Agenda Item # 5

SUB-002857-2024

Griffin Place Subdivision

APPLICATION NUMBER 5 DATE March 21, 2024

SITE PLAN

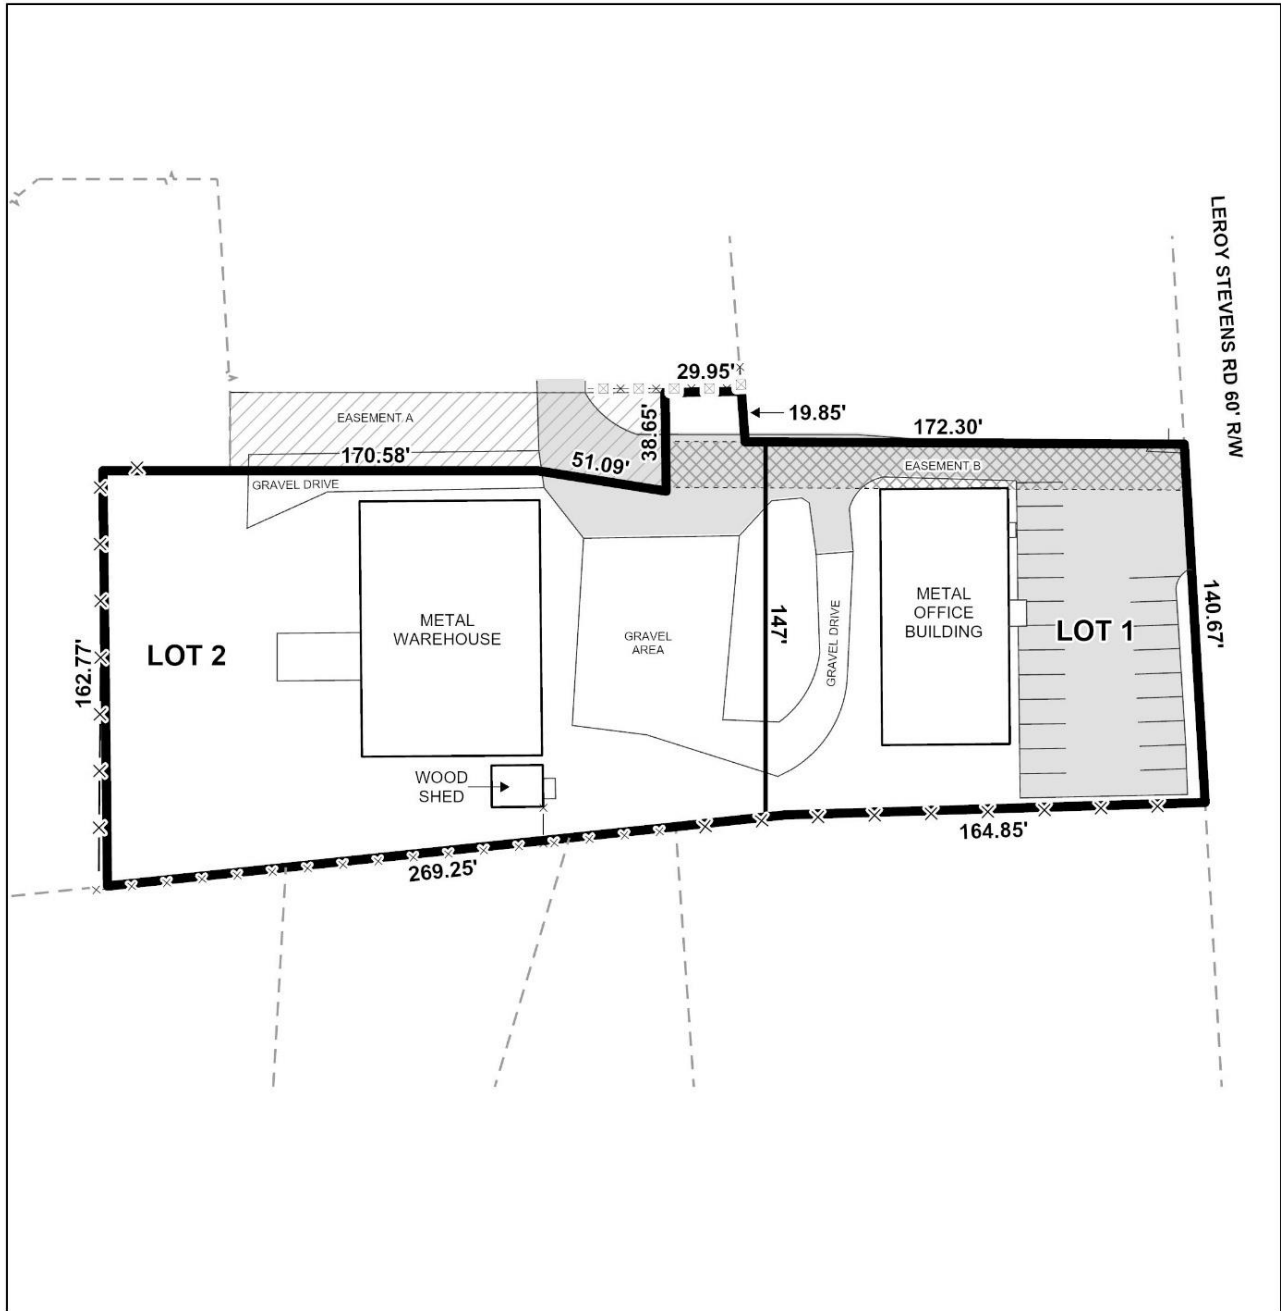
- A. Provide all of the required information on the SUBDIVISION PLAT (i.e. signature blocks, signatures, certification statements, written legal description, required notes, legend, scale, bearings and distances) that is required by the current Alabama State Board of Licensure for Professional Engineers and Land Surveyors.

- B. Add a note to the SUBDIVISION PLAT stating that as shown on the 1984 aerial photo (FLIGHT 16 - #78) LOTS 1 and 2 will receive historical credit of existing (1984) impervious area towards stormwater detention requirement per Mobile City Code, Chapter 17, Storm Water Management and Flood Control) as follows: LOT 1 – 21,000 sf AND LOT 2 – 8,500 sf.

- C. Add a note that all existing and proposed detention facilities, common areas, and wetlands shall be the responsibility of the Property Owner(s), and not the responsibility of the City of Mobile.

- D. Add a note that all easements shall remain in effect until vacated through the proper Vacation process.
- E. Revise NOTE #11 to read “ALL EXISTING AND PROPOSED...” instead of “ALL PROPOSED...”.

Proposed Lot 1 has frontage along Leroy Stevens Road, a minor street without curb and gutter requiring a 60-foot right-of-way. The plat depicts sufficient right-of-way; therefore, no additional dedication should be required.

Proposed Lot 2 does not abut a public street, as required by Section 6.C.4. of the Subdivision Regulations. Two (2) proposed ingress/egress easements are depicted on the preliminary plat (Easement A and Easement B). Easement A would provide access to an adjoining metes-and-bounds parcel that is not included in this request, and Easement B would provide access to proposed Lot 2 from Leroy Stevens Road. Article 3, Section 64-3-2.A.1. of the Unified Development Code (UDC) states that developments may be accessed by a recorded dedicated easement or other recorded legal instrument. Moreover, in an effort to limit the number of access points along city streets, shared access is encouraged wherever possible by Article 3, Sections 64-3-4.B.1. and 64-3-4.C.1. of the UDC. However, the widths of the proposed easements are substandard in that they would not accommodate two-way traffic. As such, a holdover of the request may be appropriate to allow the applicant time to revise the plat to depict easements that are at least 24-feet in width; or, the plat may be revised to depict a flag lot that would allow proposed Lot 2 to abut Leroy Stevens Road.

Both lots exceed the minimum size requirement for lots served by public water and sanitary sewer in a B-2 Suburban district, which are provided in square feet and acres in a table on the preliminary plat. This information should be retained on the Final Plat, if approved.

No front yard setback is illustrated on either lot, as required by Section 64-2-13.E. of the UDC for lots in a B-2 Suburban district. If approved, revision of the plat to illustrate at least a 25-foot front yard setback should be required, exclusive of the ingress/egress easement. For Lot 2, this would mean placing a setback 25-feet from the easement wherever the lot is at least 60 feet in width.

Both proposed lots are developed: Lot 1 with a metal office building and parking lot; and Lot 2 with a metal warehouse, wooden shed, and gravel maneuvering area. Both lots appear to have access to Leroy Stevens Road via an asphalt drive located within the aforementioned ingress/egress easement.

While Lot 1 appears to comply with off-street parking requirements, approval of the subdivision would create a non-conforming condition on Lot 2 in that it does not have a parking lot to accommodate parking for the warehouse use. As such, further development of Lot 2 would be subject to the Non-Conforming provisions of Article 6 of the UDC.

A note on the plat states no structure shall be constructed or placed within any easement without the permission of the easement holder. This note should be retained on the Final Plat, if approved.

1. Revise the plat to illustrate ingress/egress easements that are at least 24 feet in width; or
2. Revise the plat to depict a flag lot that would allow proposed Lot 2 to have frontage on Leroy Stevens Road.
